REPORT TO CITY PLAN COMMISSION

Item: Preliminary/Final Plat/ Second Addition to Clearwater Creek

TO: Brad Schmidt
FROM: Pete Neuberger / Ross Buetow
DATE: June 16, 2014
RE: Clearwater Creek 2nd Addn. Drainage Plan / Stormwater Management Plan Comments

DRAWING NO. **S-2344**
SHEET NO. **C1.0**
PROJECT NO. **VISION RAEITY & DEV., LLC**
GRADING & SITE UTILITY PLAN
FILE: V-014E-tp 10/11.dwg

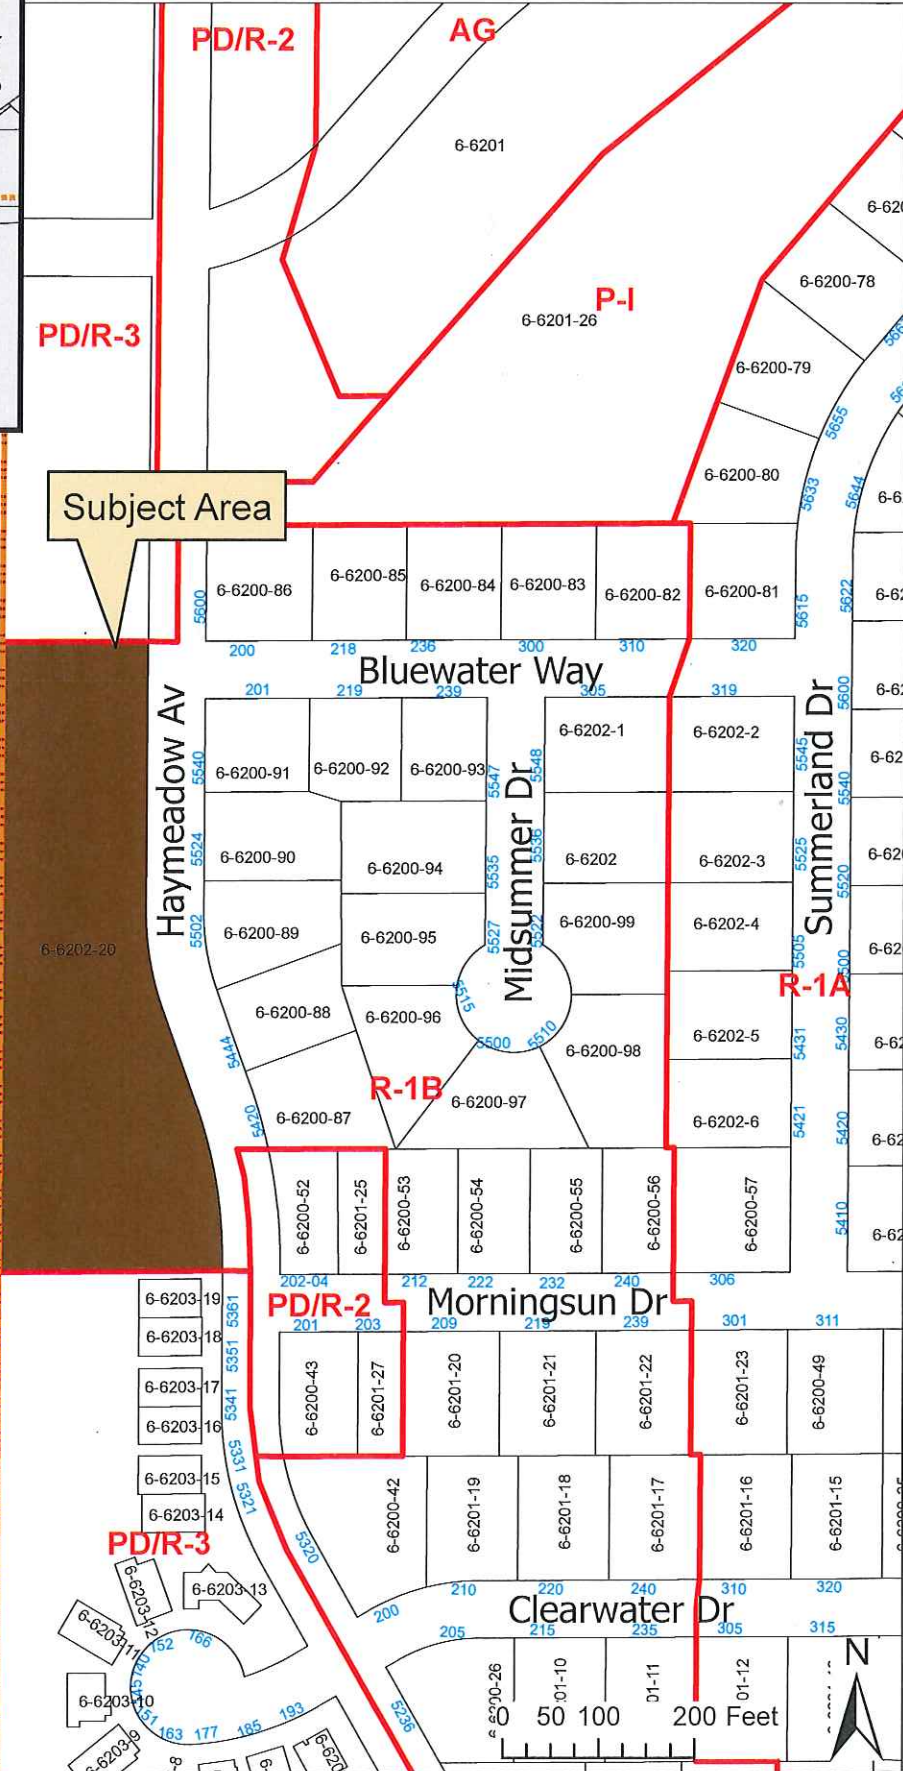
1. The Drainage Plan as submitted is labeled “Grading and Site Utility Plan”. The required Drainage Plan is a separate document from the Grading and Site Utility Plan and must show different information. Label the Drainage Plan as such.

2. Remove the sanitary manhole schedule and sanitary sewer information
3. Remove the note that reads “Exact grades...”
4. Remove the note that reads “Developers/Owners have...”

6. Provide the following information with corresponding symbol legend:
 - a. Storm Sewer
 - b. Storm Manhole
 - c. Storm Inlet/Yard Drain
 - d. Proposed Spot Elevations (required at all lot corners and lot line grade breaks)

14. For proposed spot grades, show only spot grades along lot lines and in easements for major drainage swales.
 - a. Do not show proposed contours/spot elevations for interior site drainage

- b. Do not show building foundations, driveways, or Top of Foundation elevations.

15. Provide spot elevations and drainage direction arrows for the major drainage swale that approximately follows the public storm sewer alignments immediately east of the rear yard landscape berm.

16. Provide drainage direction arrows along all lot lines and swales.
17. Provide a berm cross-section detail. Since the berm (according to the Clearwater Creek 1st addition drainage plan is 35.5' wide, the 40' wide storm sewer and landscape easement does not provide enough room to maintain the storm sewer. Label the adjacent 12' utility easement also as "Storm Sewer & Drainage" easement. Show this on the Plat as well.

18. Label the 20' Storm Sewer Easement along the north lot line of Lot 121 also as "Drainage Easement". Show this on the Plat as well.
19. Use different line types to differentiate easement boundaries from lot boundaries.

20. Provide spot grades along the north lot line of Lot 121 and any spot grades/drainage direction arrows as may be needed to provide for adequate collection/conveyance of stormwater runoff so as to prevent runoff from entering the parcel north of Lot 121.

21. Provide Rim elevations of all storm manholes/inlets/yard drains outside street right-of-way.
22. Provide spot elevations along the west plat line, indicating to match existing grades.
